[Docket No. FAA-2011-1115; Directorate Identifier 2010-SW-011-AD; Amendment 39-17017; AD 2012-08-01]

Airworthiness Directives; Sikorsky Aircraft Corporation Helicopters

2012-08-01 Sikorsky Aircraft Corporation:

Figure 1. Cat 'A' Takeoff and Landing Gross Weight

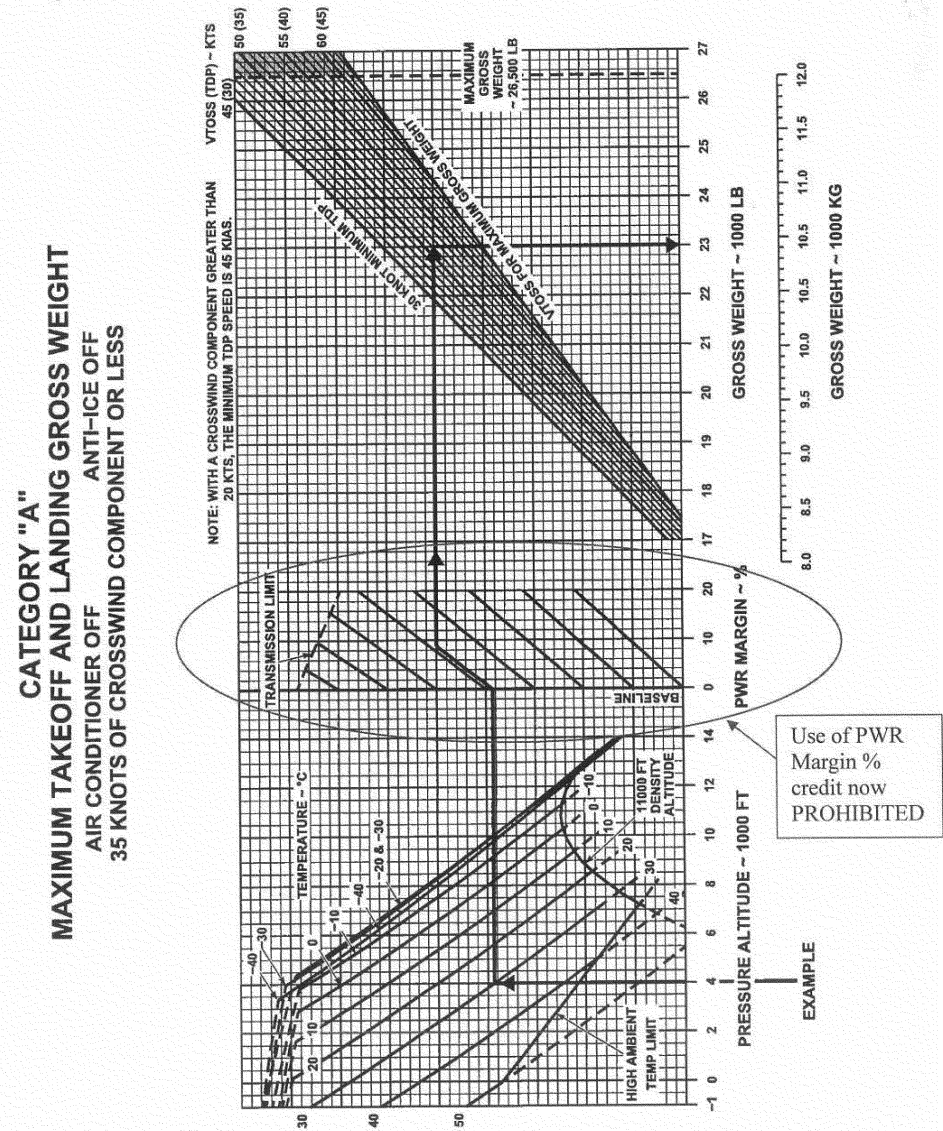
(1) By making pen and ink changes, insert into the Operating Limitations section, Part 1, Section 1, Weight Limits, of Rotorcraft Flight Manuals (RFMs) SA S92A-RFM-002, -003, -004, -005, and -006 the following limitation “Performance credit for above specification engine power margin is prohibited.”

(2) If the RFM already contains the revisions appropriate for your helicopter as listed in the following Table 1, all dated April 9, 2008, with the correct performance charts, without the performance credit as depicted in the circled area of Figure 1 of this AD, the operating limitation required by paragraph (1) of this AD does not need to be inserted into the RFM.

Note to paragraph (e)(2) of this AD:
Previous RFM revisions allowed for the use of above-specification engine power margin as depicted in the circled area of Figure 1 of this AD.
